GOVERNMENT OF THE DISTRICT OF COLUMBIA
DEPARTMENT OF TRANSPORTATION

MEMORANDUM

SUBJECT: ZC Case No. 15-01 – Highline (320 Florida Ave NE)

Figure 1 Site Design and Access (Source: Gorove/Slade)

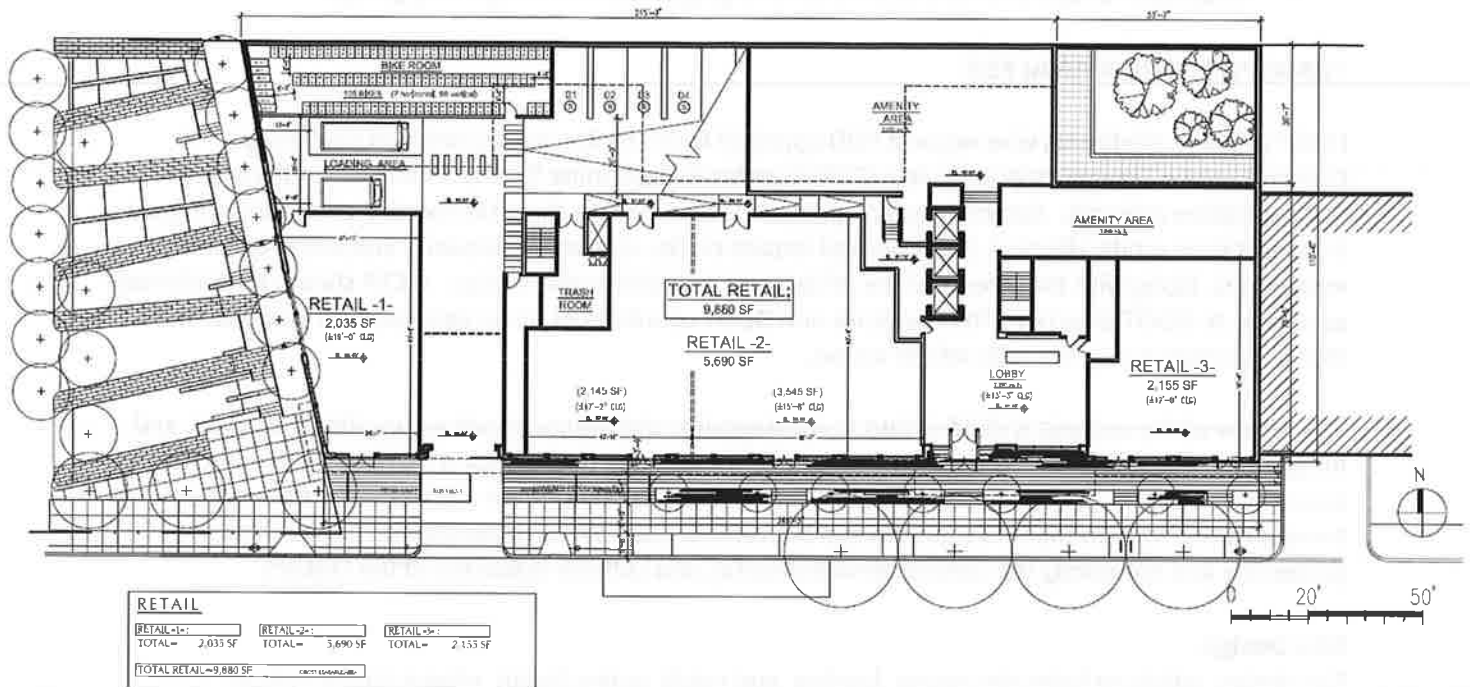
Vehicle site access is proposed from the existing Florida Avenue/3rd Street signalized intersection, in compliance with DDOT standards. Further study will be required during permitting to determine if improvements to the existing traffic signal may be needed. The Applicant will be responsible for any needed improvements.

network to serve development within the Market. The Applicant proposes to accommodate this connection in a proffered park to the west of the site adjacent to the train tracks. The land for the proposed park is owned by the Department of General Services. Future developments to the north will be expected to create a bicycle and pedestrian connection between Morse Street and the park. The Applicant has committed to funding and constructing the park. The park is located on a hill slope and will require substantial system of stairways in order to accommodate the grade. In order to ensure the park makes adequate pedestrian and bicycle connections, sidewalk widths of at least 8 feet should be provided throughout. Additionally, a bike channel should be provided on all staircases to assist with cyclists walking their bicycles up or down the hill.

Loading access is proposed from the existing Florida Avenue/3rd Street signalized intersection. The loading facilities are designed such that loading is accommodated with front-in/front-out movements in compliance with DDOT standards.

Florida Avenue does not include any space for curbside uses such as parking or loading, and therefore there are no opportunities load from the curbside. Thus, all loading must be accommodated on-site and loading activities from Florida Avenue will be prohibited. As currently designed, "Retail 3" does not have

direct access to the loading facilities via an interior service corridor, but it is accessible via the residential lobby. Loading materials will be required to be brought through the lobby.

The Applicant's plans show a series of canopies extending laterally along a significant portion of the building façade and projecting a maximum of 9 feet from the building façade. The canopies, as shown, do not meet regulations for canopies and will require a modification from the Building Code. The final design of the canopies will be addressed during permitting.

The final element of the plan should be clarified to make it explicit that loading shall not take place from the Florida Avenue curbside. Trucks accessing the on-site loading berths should route to the site using Florida Avenue since it is a designated truck route.
